STATION FLATS JSP 23-02

Resume the public hearing from June 21st at the request of Cypress Partners, LLC for recommendation to the City Council for Amendment of the Consent Judgment that governs development of the property. The subject property is located on the east side of Wixom Road, south of Grand River Avenue (Section 17). The applicant is proposing 157 apartment units in a four-story building. The Consent Judgment permits 100,000 square feet of retail use conforming to the B-2 Community Business standards on the subject parcel. The proposed use is most consistent with the RM-2 High-Density Multiple Family Residential District.

Motion Sheet

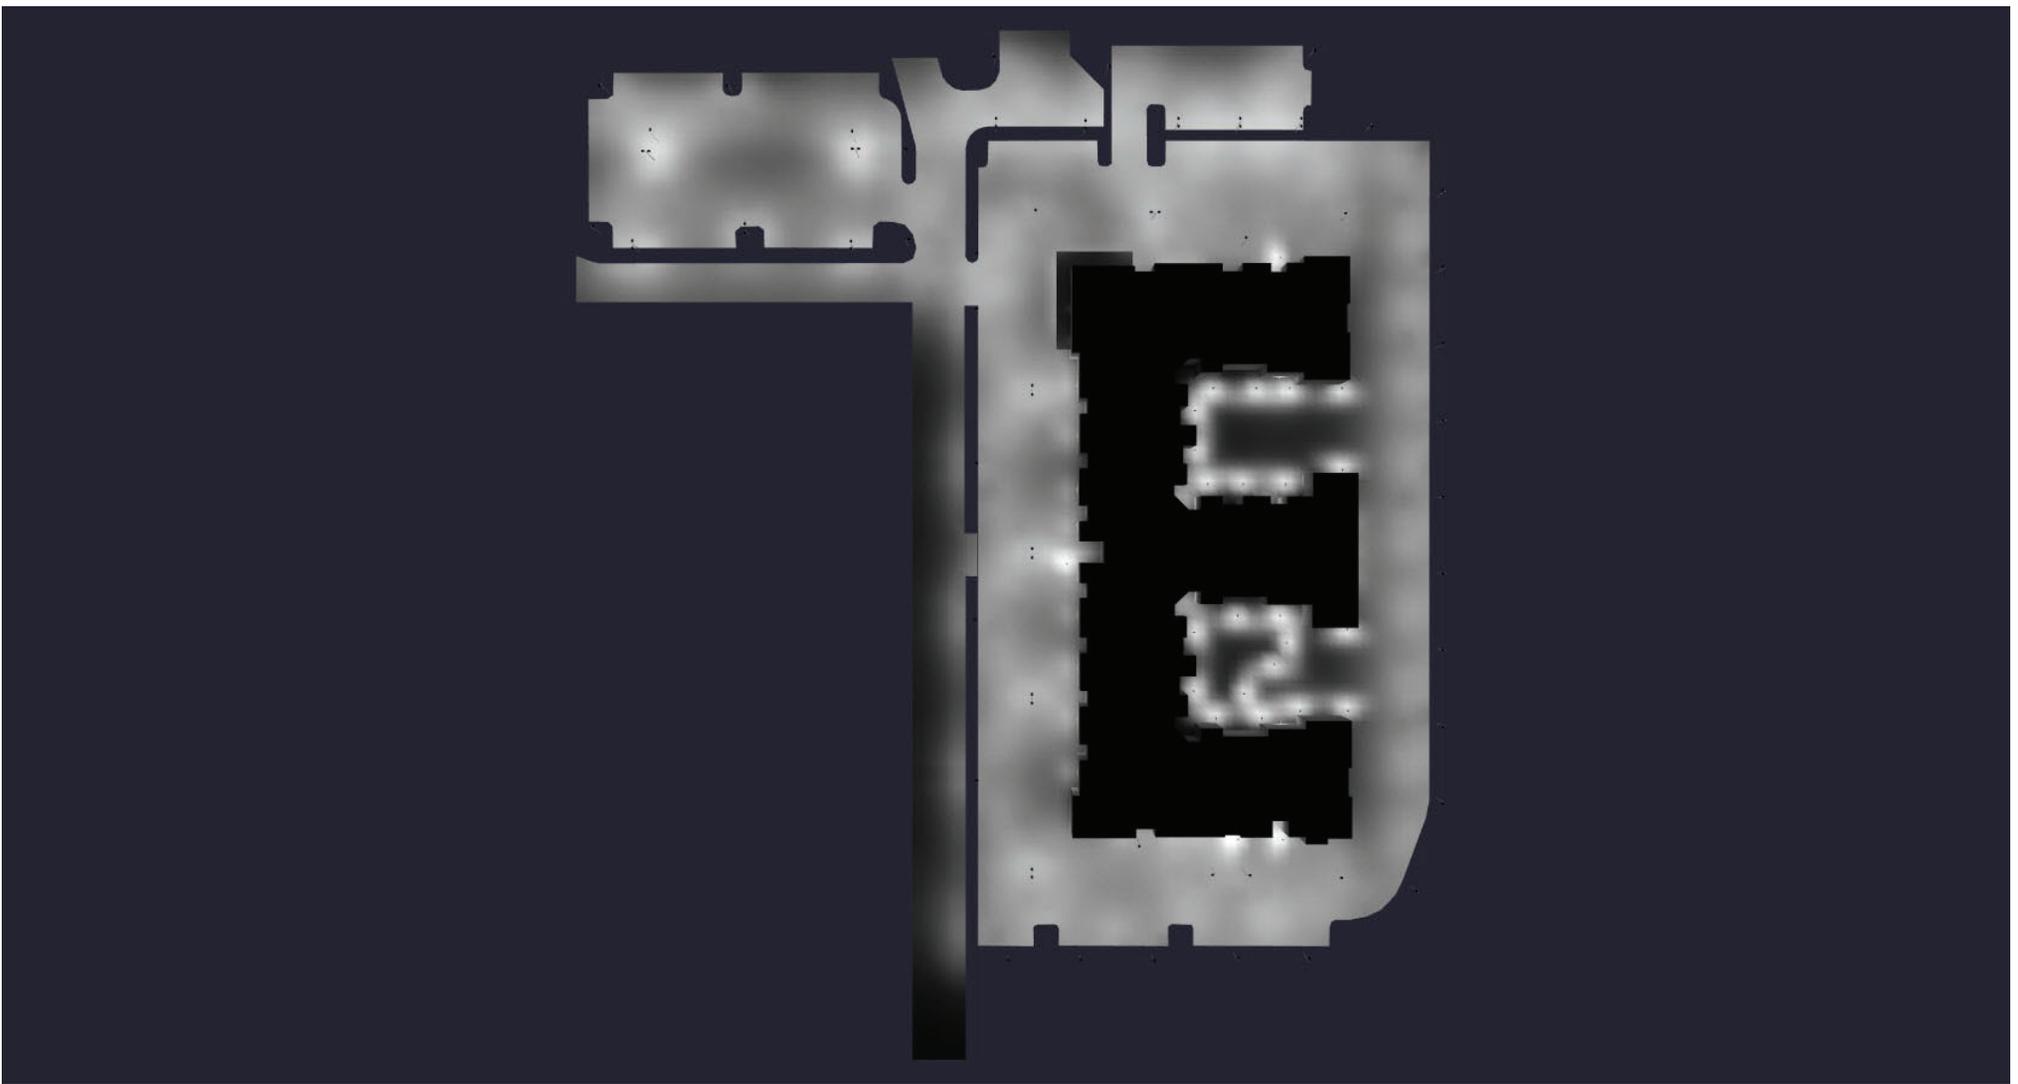
2. Lighting & Photometric Plan (Sec. 5.7): There are several items that should be addressed on the photometric plan with the next submittal as listed below.
 - a. Average to Minimum Ratio (Sec. 5.7.3.E): **According to GBA sheet 1 of 8 the Ave/Minimum ratio exceeds the maximum ratio of 4:1 in several locations. Revise or seek a deviation in the Consent Judgment.**
 - b. Lighting Specifications (Sec. 5.7.A.2.ii): **Please provide specification sheets for the proposed light fixtures, fixture mounting detail, fixture design, and fixture hours of operation in the plan set at the time of site plan submittal.**

Average Light Level (Sec.5.7.3.E)	Average light level of the surface being lit to the lowest light of the surface being lit shall not exceed 4:1	Some locations exceed up to	No	According to GBA sheet 1 of 8, some areas of site exceed 4:1. Applicant will need to seek deviation as part of the amendment to the Consent Judgment.
Lighting Type (Sec. 5.7.3.F)	Use of true color rendering lamps such as metal halide is preferred over high & low pressure sodium lamps	LED Lighting	Yes	
Min. Illumination (Sec. 5.7.3.K)	Parking areas: 0.2 fc min	0.5 fc	Yes	Revise the main entrances to meet 1.0 foot candle minimum.
	Loading & unloading areas: 0.4 fc min	1 fc	Yes	
	Walkways: 0.2 fc min	0.3 fc	Yes	
	Building entrances, frequent use: 1.0 fc min	0.8 fc	No	
	Building entrances, infrequent use: 0.2 min	0.4 fc	Yes	
Max. Illumination adjacent to Non-Residential (Sec. 5.7.3.K)	When site abuts a non-residential district, maximum illumination at the property line shall not exceed 1 foot	0.5 fc	Yes
